F6 Extension Stage 1

Submissions report

Appendix B
Air quality impacts for
elevated receptors

2.0 Assessment of impacts at elevated receptors (NSW EPA)

Figure 1 RWR receptors for existing tall buildings to the north-east of the Arncliffe ventilation outlet

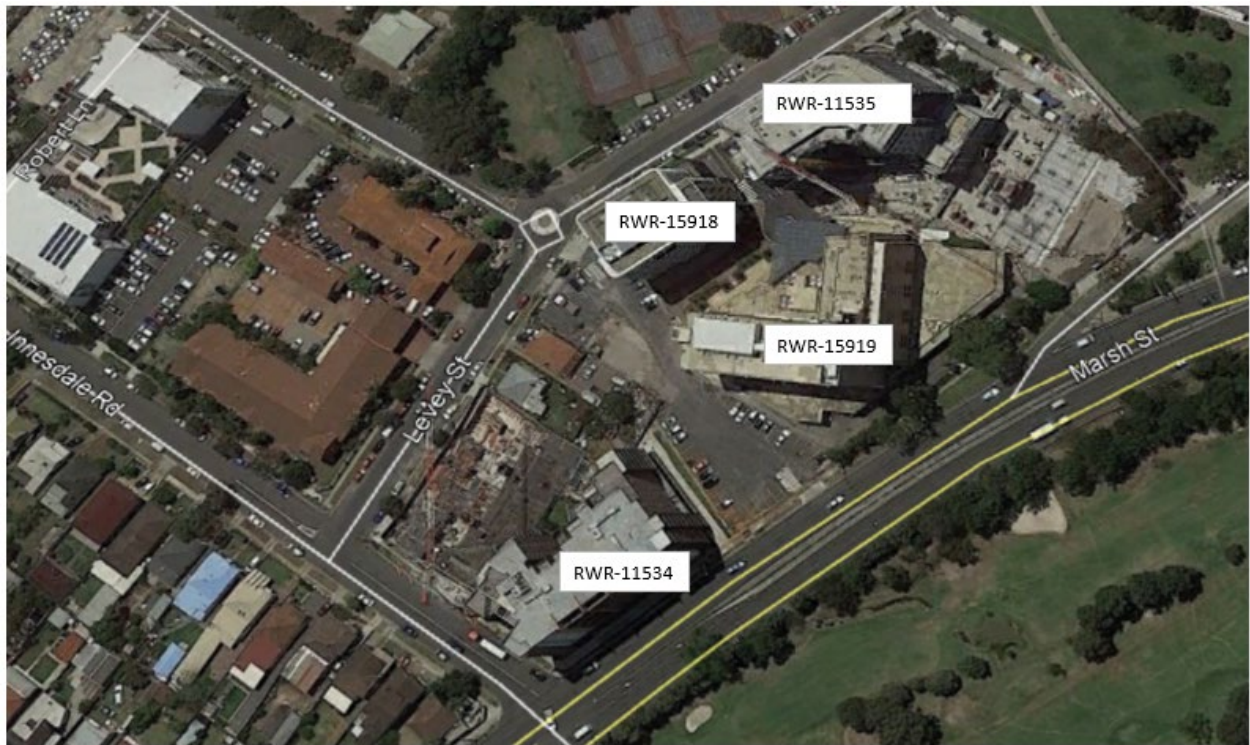
- *Confirm receptor heights located in proximity to ventilation outlets given the significant data gaps on building height described within the Air Quality Technical Report;*
- *Present predicted impacts for all pollutants and averaging periods for receptors located at height in proximity to ventilation outlets. This includes 1-hour average air toxics and for relevant pollutants accounting for background air quality;*
- *Present predicted impacts for all pollutants and averaging periods for receptors located at height in proximity to ventilation outlets, for the regulatory worst-case scenario.*

- North of the Arncliffe ventilation facility towards Cahill Park, building heights are significantly higher and range between 17.5 metres and 29.5 metres in the high density residential zoned area and 46 metres in the mixed use zoned areas. This area is located approximately 260 metres away (at its closest point). The closest elevated receptors to the Arncliffe ventilation facility are in the area bounded by Marsh Street, Innesdale Road and Levey Street, approximately 240 metres away and the receptors in these buildings are lower than the 46 metres mixed use height restriction in the LEP.

(a) Existing tall buildings in the proximity of the tunnel ventilation outlets were identified. The RWR receptors identified with these buildings are shown in **Figure 1** and **Figure 2**.

At the existing tall buildings there was, in many cases, a negative concentration increment.

Where there was predicted to be a positive concentration increment for the existing tall buildings, the largest values were generally at a height of 30 metres or 45 metres.
